SUBJECT: KINGSTON STEAM PLANT - ANNUAL ASH DISPOSAL AREA INSPECTION

SUBJECT: KINGSTON STEAM PLANT - ANNUAL ASH DISPOSAL AREA INSPECTION

KINGSTON STEAM PLANT

PLAN - RAISING ASH DISPOSAL

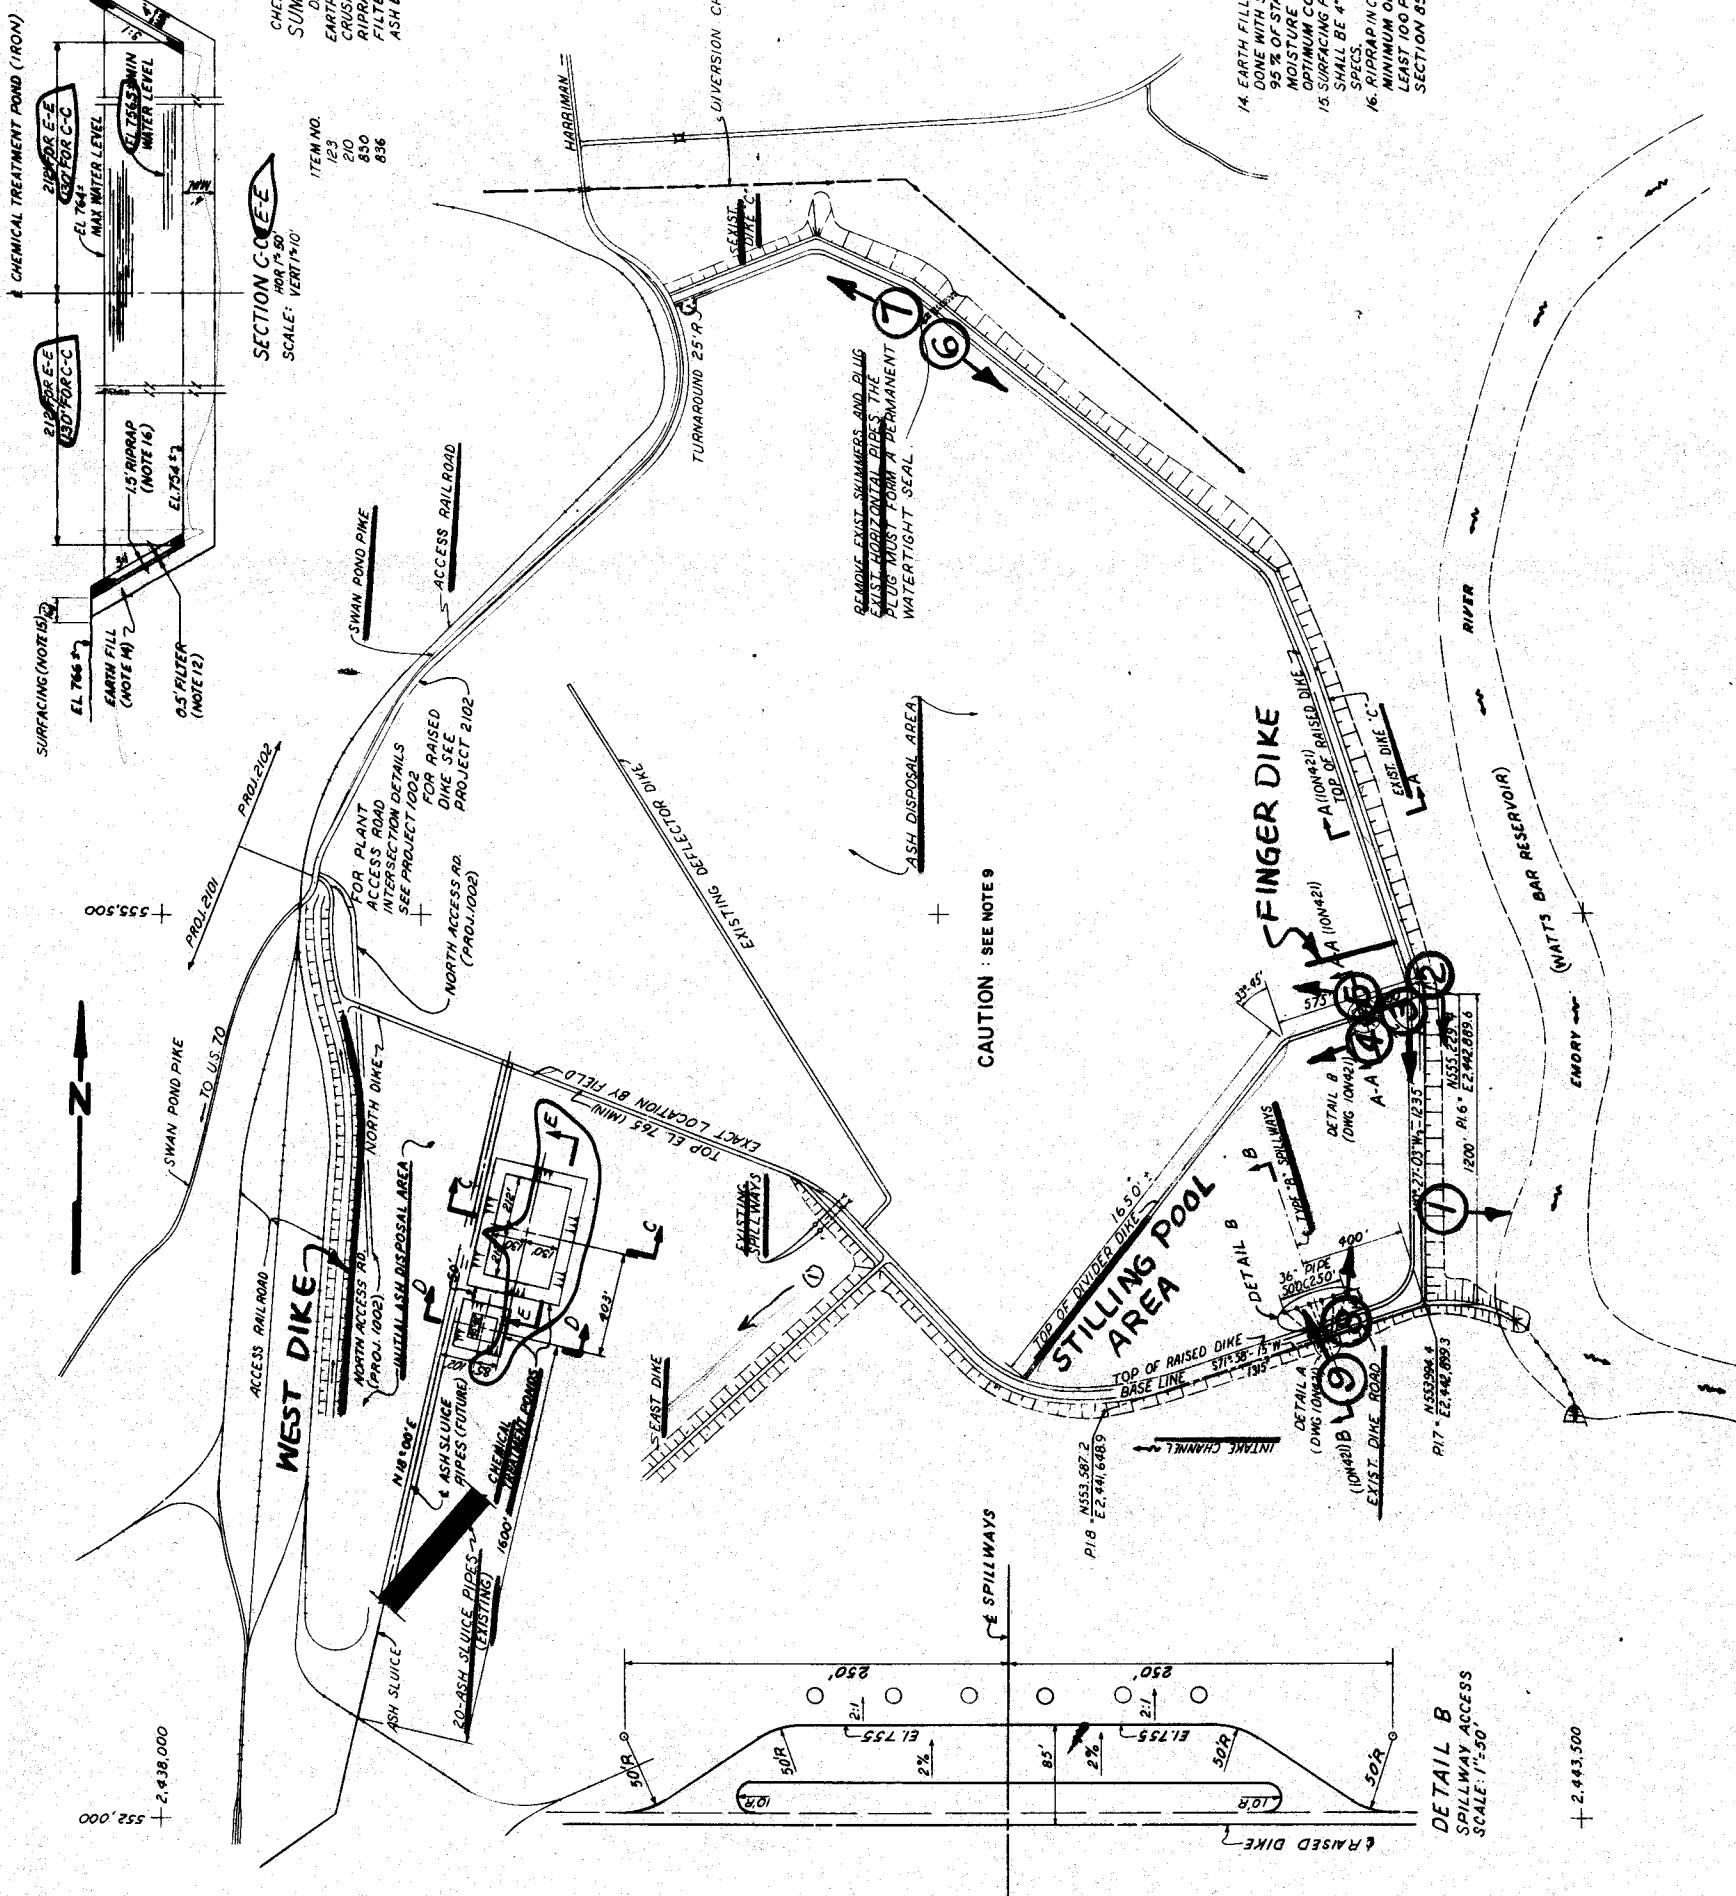
On the attached print of drawing 10N420, the different areas are designated.
